REVISION LOG

Lot 20 Duncan's Creek
275 Beacon Hill Road
Lillington, NC 27546

**The Durham - RH
ELEVATION 'D'**

SLAB FOUNDATION - ELEVATION 'D'
SCALE: 1/4" = 1'-0" ON 22x34, 1/8" = 1'-0" ON 11x17

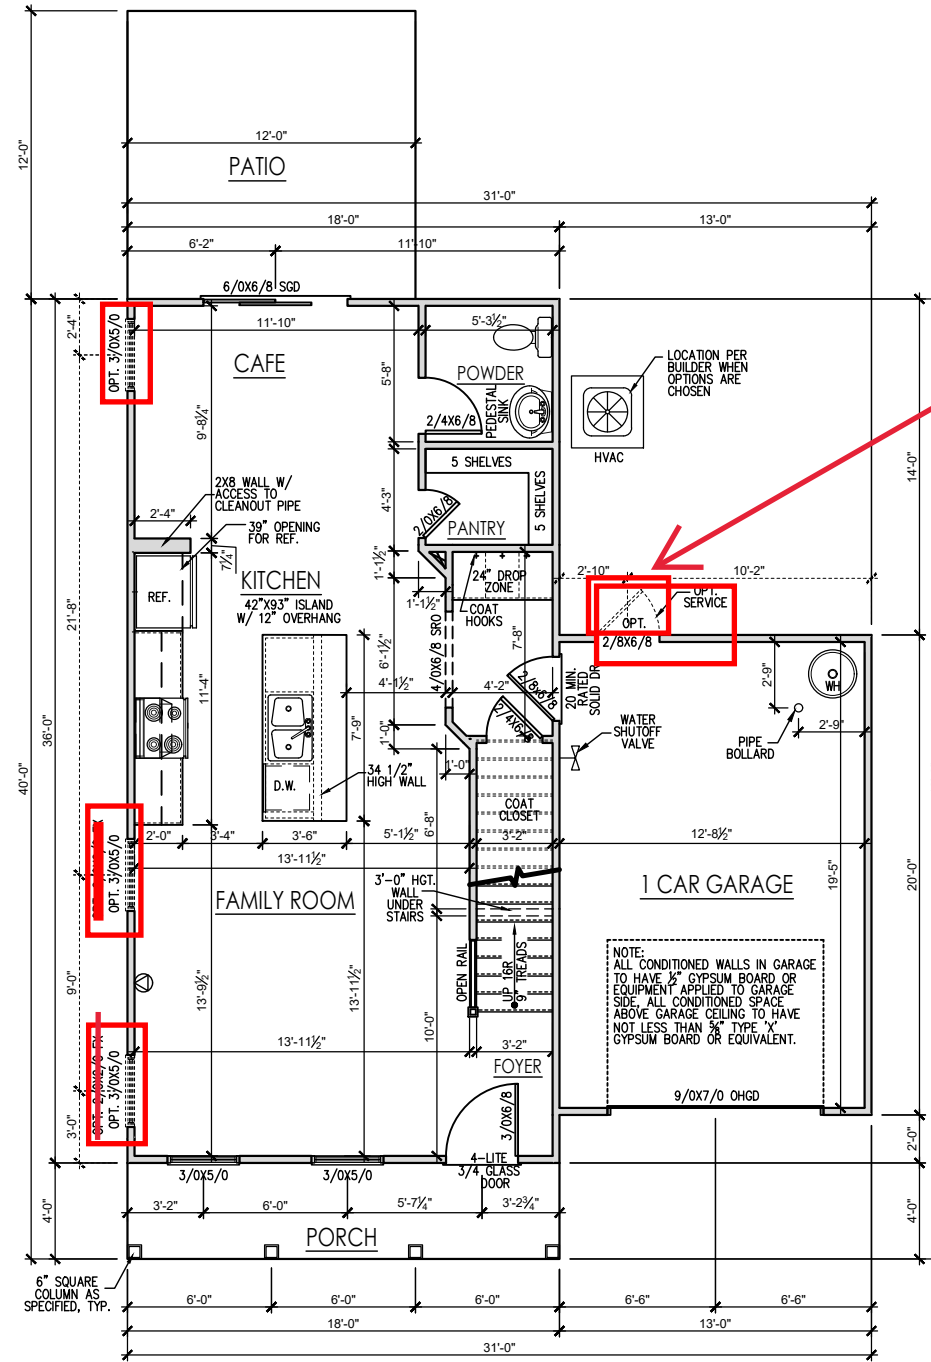
3' x 3' conc pad at
Opt Pedestrian Door

SLAB FOUNDATION - ELEVATION 'D'

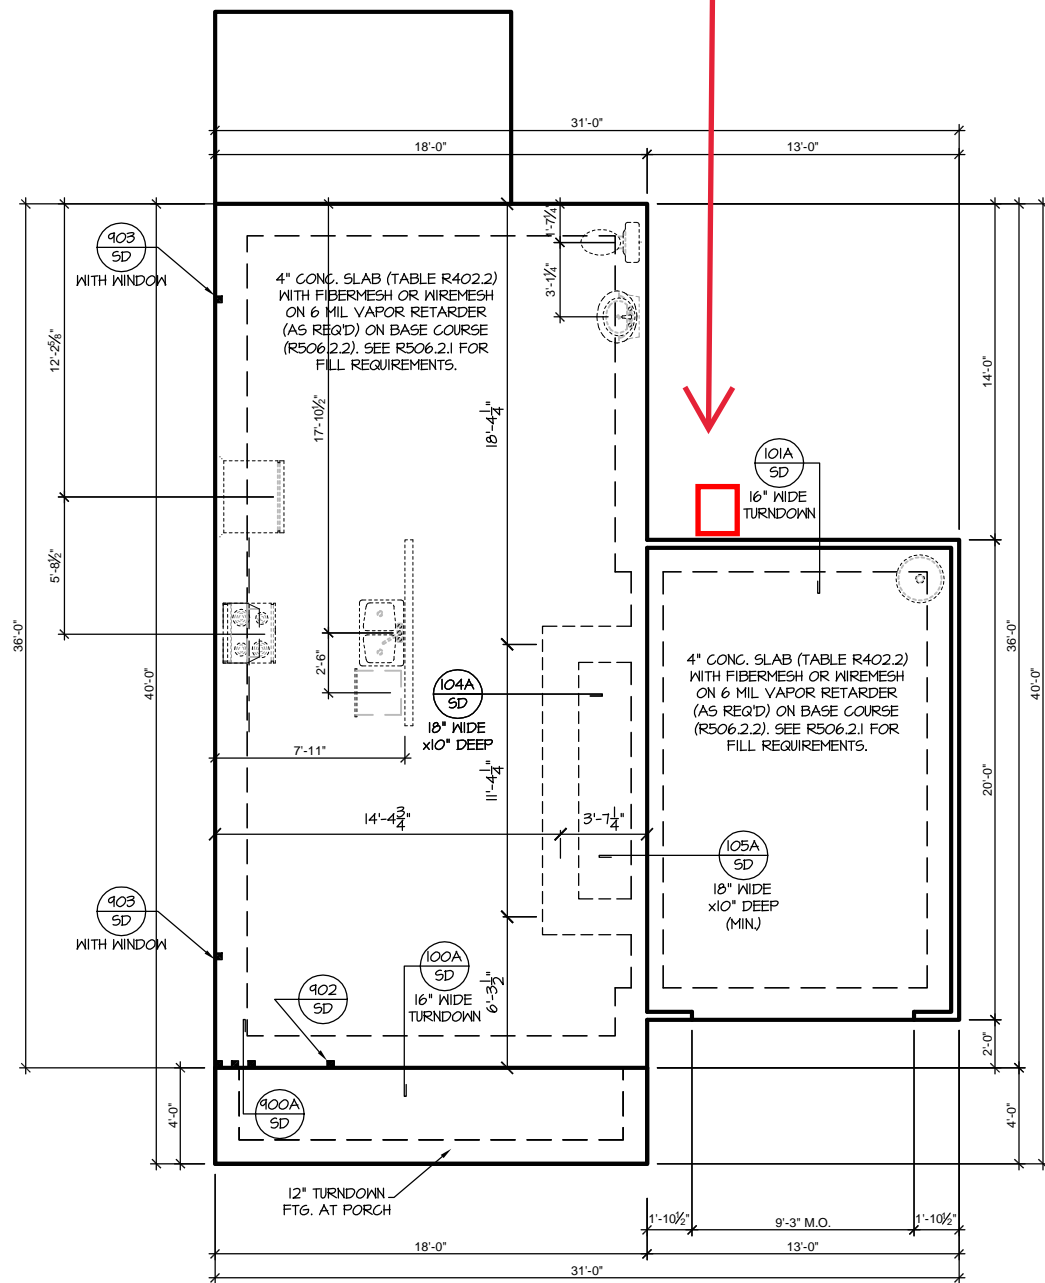
add 3' x 3' Conc pad
at Opt Pedestrian Door

FIRST FLOOR - ELEVATION 'D'

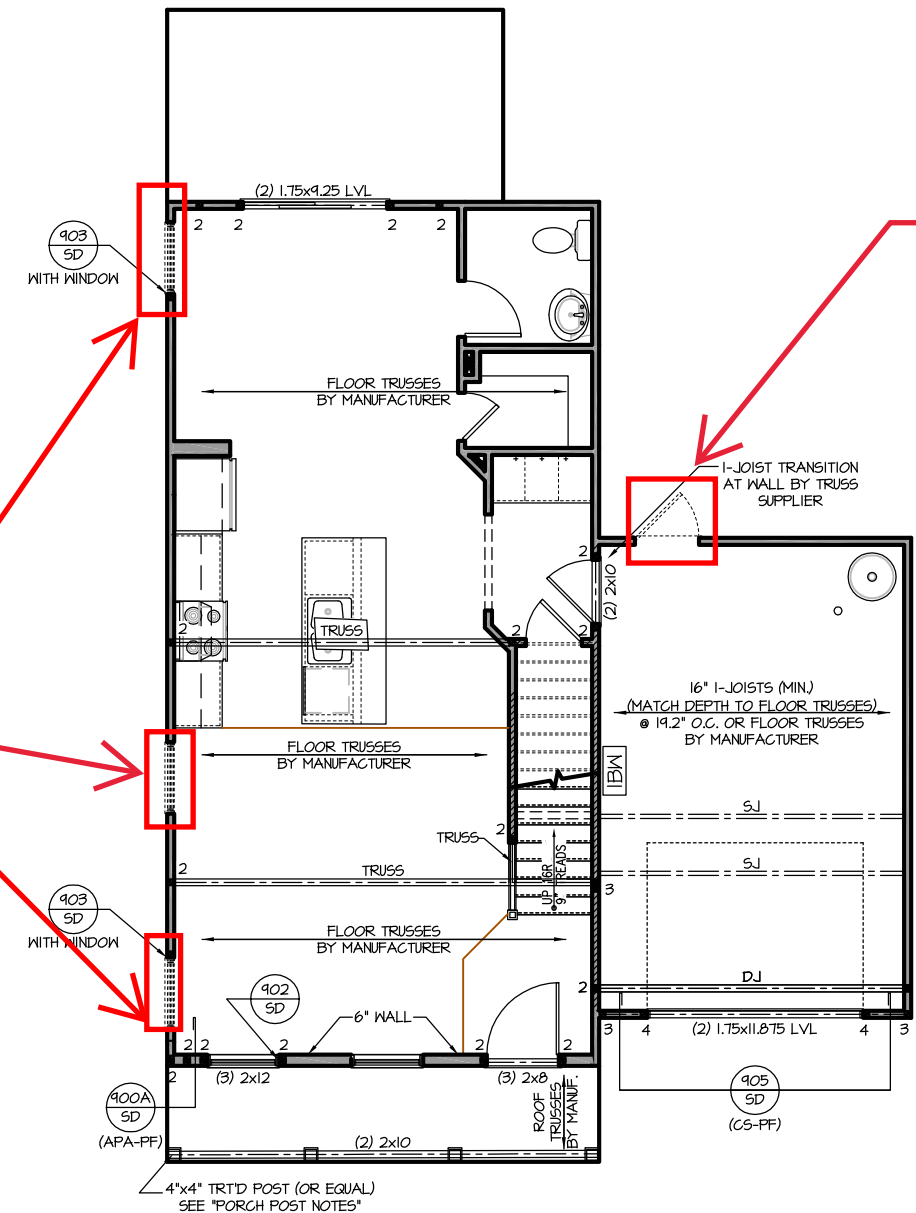
Opt 3/0 5/0 Windows

Add 3' x 3' concrete pad at Opt Pedestrian Door
